**LEXINGTON-FAYETTE URBAN COUNTY  
GOVERNMENT CONTRACT CHANGE ORDER**  
Page 1 of 2

Date:	December 28, 2015
Project:	Senior Citizen Center Construction
Location:	Lexington
Contract No.:	227-2014
Original Contract Amt.:	\$8,882,900.00
Cumulative Amount of Previous Change Orders	\$1,417,353.37
Percent Change - Previous Change Orders	15.96%
Total Contract Amount Prior to this Change Order	\$10,300,253.37
Change Order No.:	33

CHANGE ORDER NO. 33

**Pending Owner Approval**  
**PR-57 Credit for the Sunscreen Columns per Proposal Request No. 41**

**A4.41**

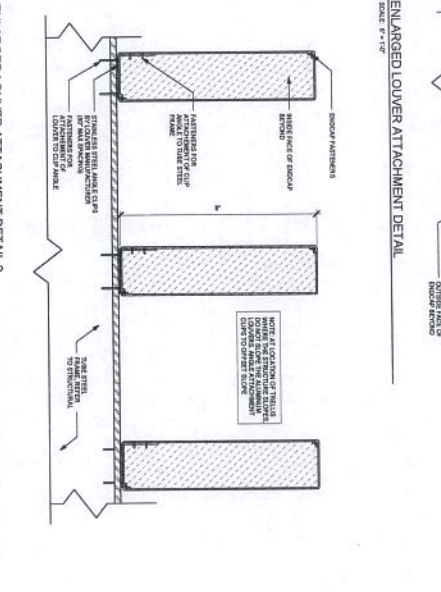
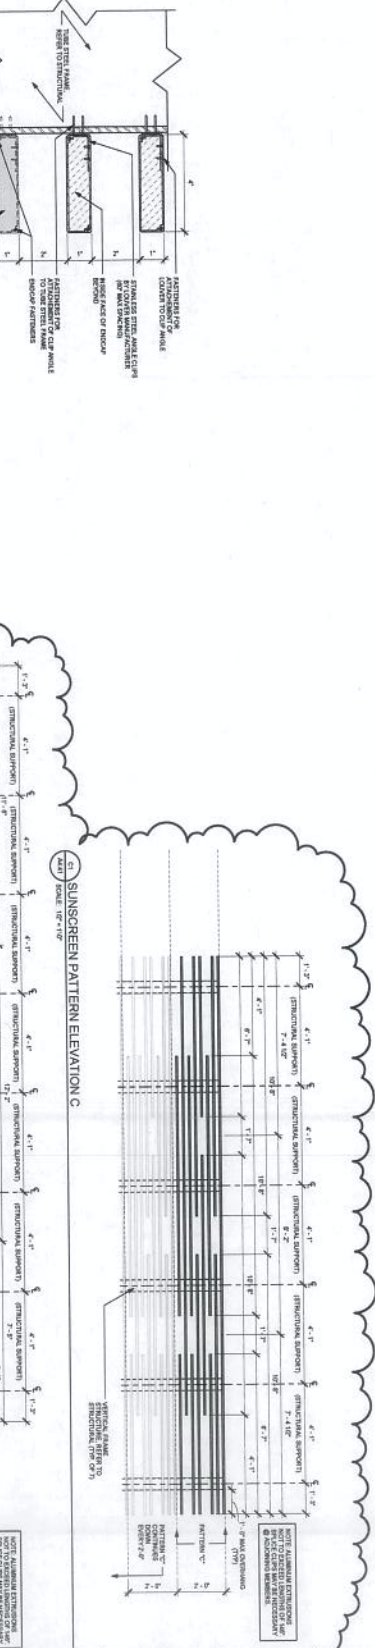
Please provide credit pricing for reduced number of extruded aluminum elements and associated miscellaneous metals associated with the two sunscreens at the southeast corner of the building. Vertical supports were not included in structural drawings. Area of sunscreen and element pattern has been adjusted. Please provide credit breakdown for reduced materials, labor, equipment time/rental as applicable, and subcontractor overhead and profit.

Sunscreen shall be laid out per the attached revised sheets A4.40 and A4.41.

**SKS-21**

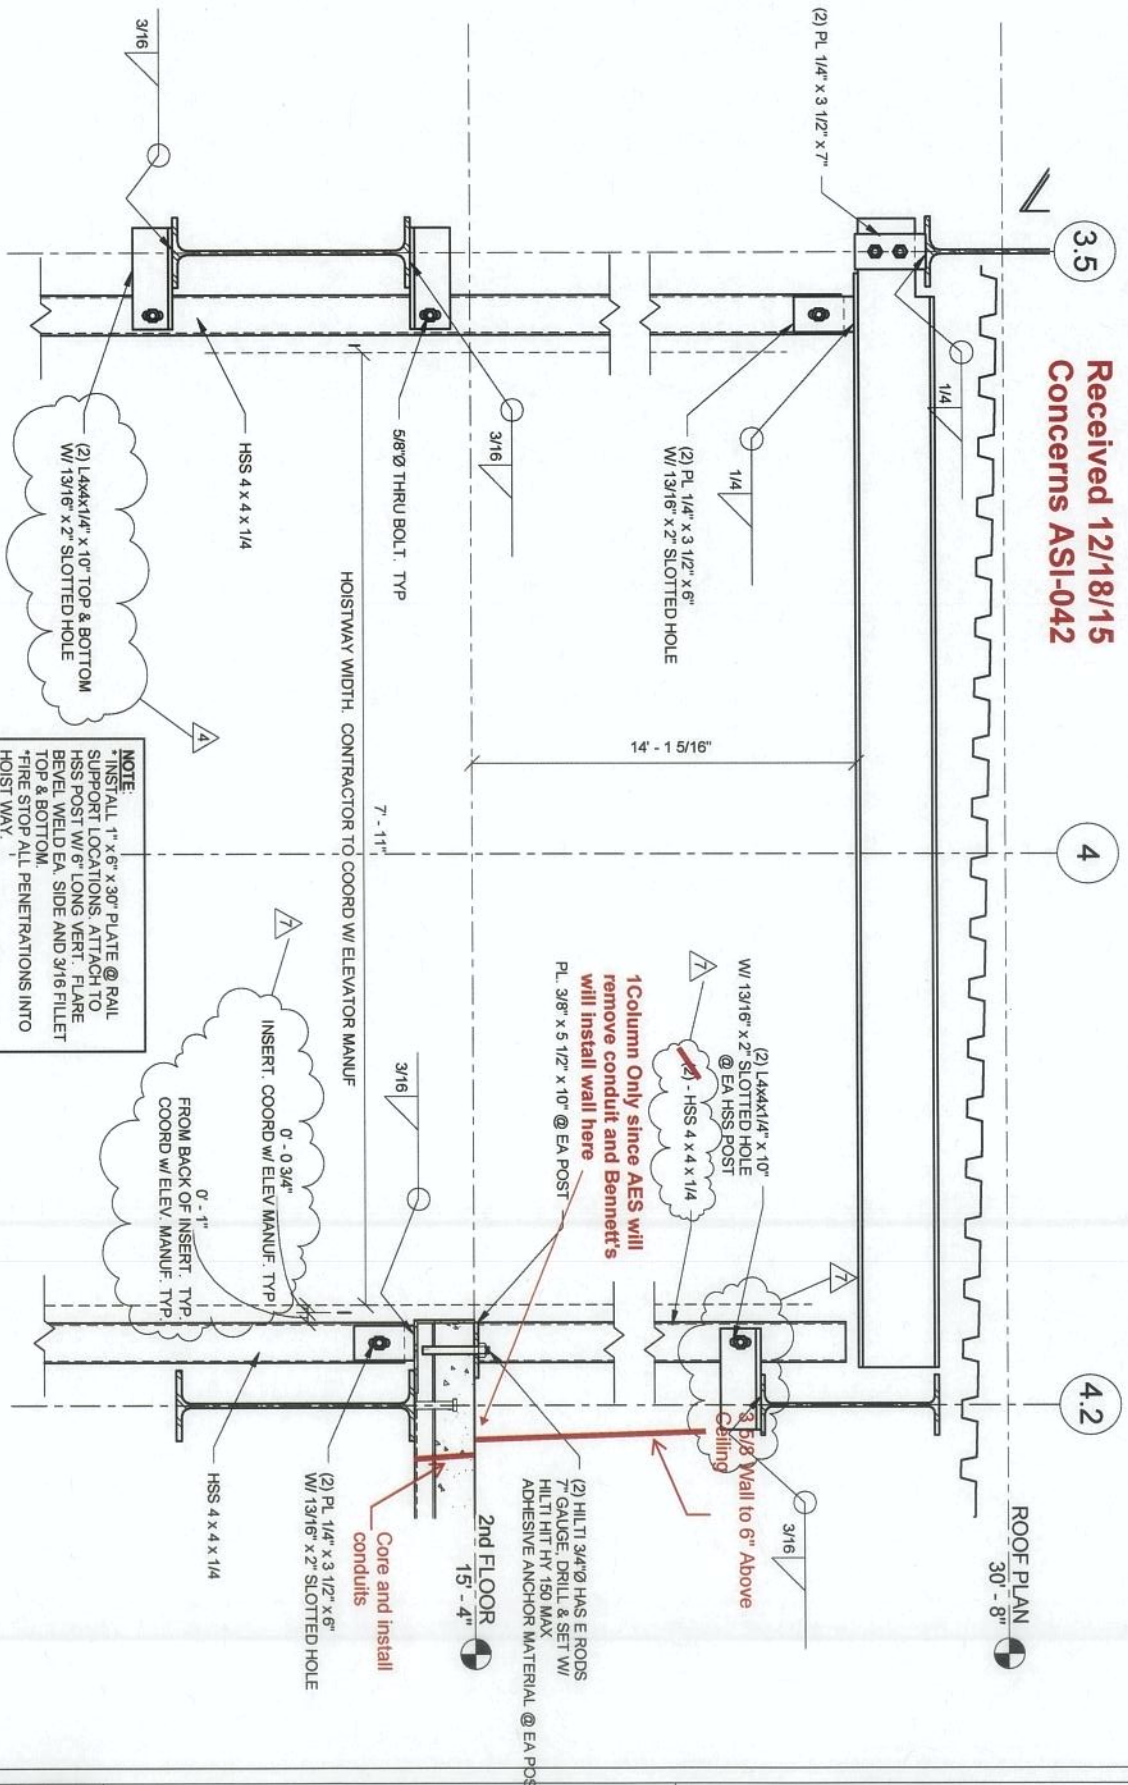
The original drawing shows these tube steel columns going floor to floor. Detail [A] on ISC drawing E-3. These columns are fabricated to this drawing. Per ASI-042 the columns are changed to drawing SKS-21. Adding additional Tube steel, 4 x4 clips, through bolts and slotted holes. The hoist beam also has been installed per the drawings and it is a foot off center and it will have to be moved. Per the elevator drawings, plates approx. 10 [ 1"x 6" x 30"] will need to be supplied and installed on the tubes for guide rail supports.

Add an additional 4 x4 x1/4" tube steel column on the north side of elevator line 4.2 and all related plates and clips.

**NOTE:**  
\*INSTALL 1" x 6" x 30" PLATE @ RAIL  
SUPPORT LOCATIONS. ATTACH TO  
HSS POST W/ 6" LONG VERT. FLARE  
BEVEL WELD EA. SIDE AND 3/16 FILLET  
TOP & BOTTOM.  
\*FIRE STOP ALL PENETRATIONS INTO  
HOIST WAY.

1 Column Only since AES will  
remove conduit and Bennett's  
will install wall here  
PL. 3/8" x 5 1/2" x 10" @ EA POST

**SKS-20**

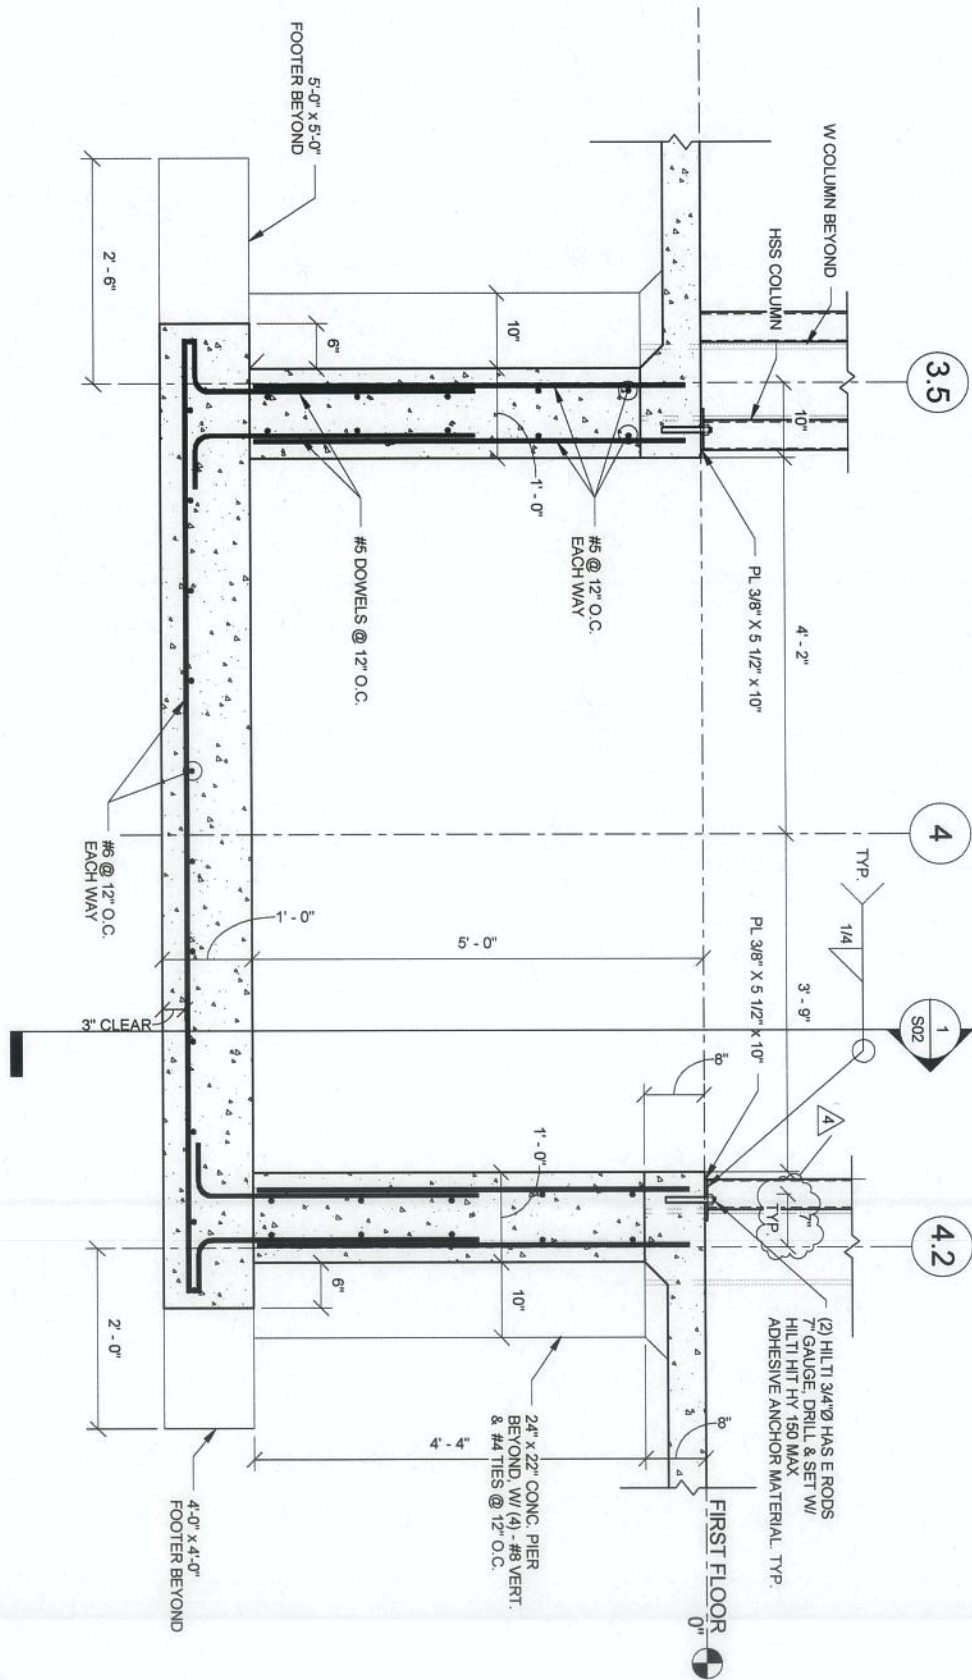
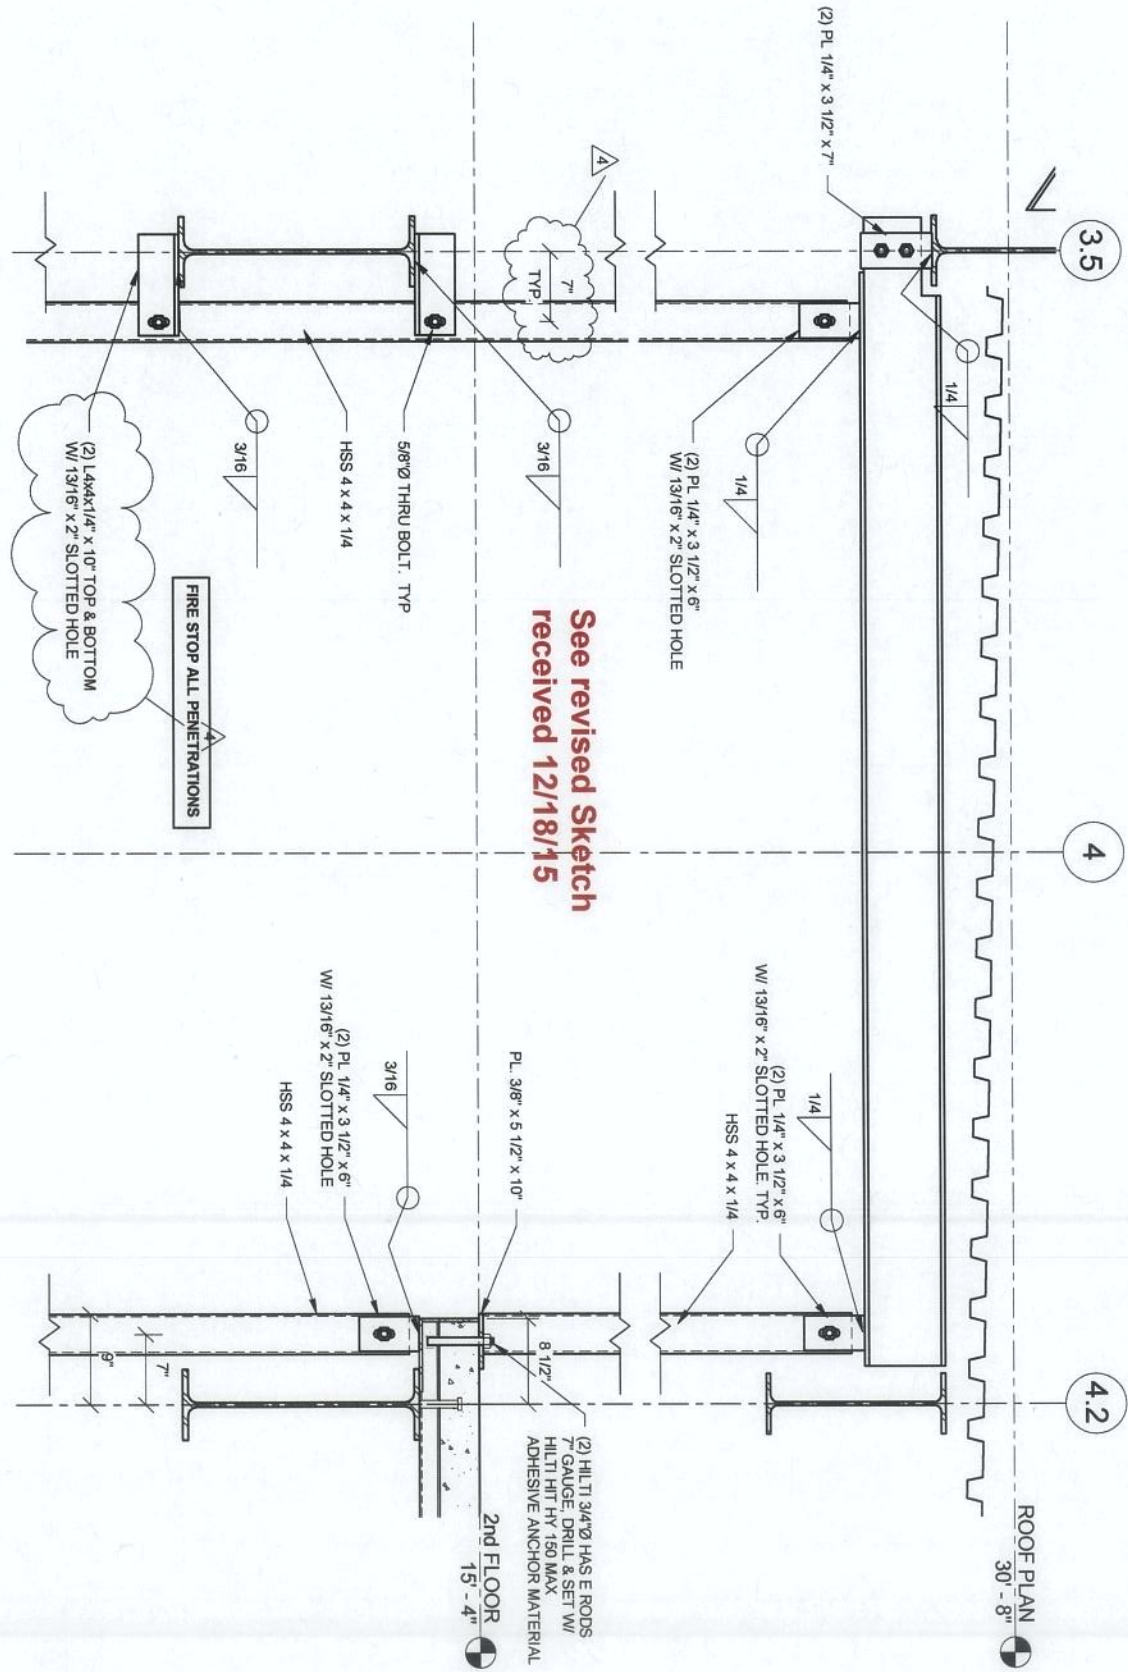
Please see the attached sketches for revised location of the HSS columns that support the elevator rails. If the 30"x6" steel plate method of rail attachment is used, the thickness of the plate should be 1", and the hoistway-side face of the plate should be flush with the hoistway-side face of the shaft liner panel. This and all penetrations must be firestopped to achieve a 1-hour rating. The design intent is for the shaft liner panels to be otherwise continuous, and for the shaftwall framing to frame into/around the HSS columns.

See revised Sketch  
received 12/18/15
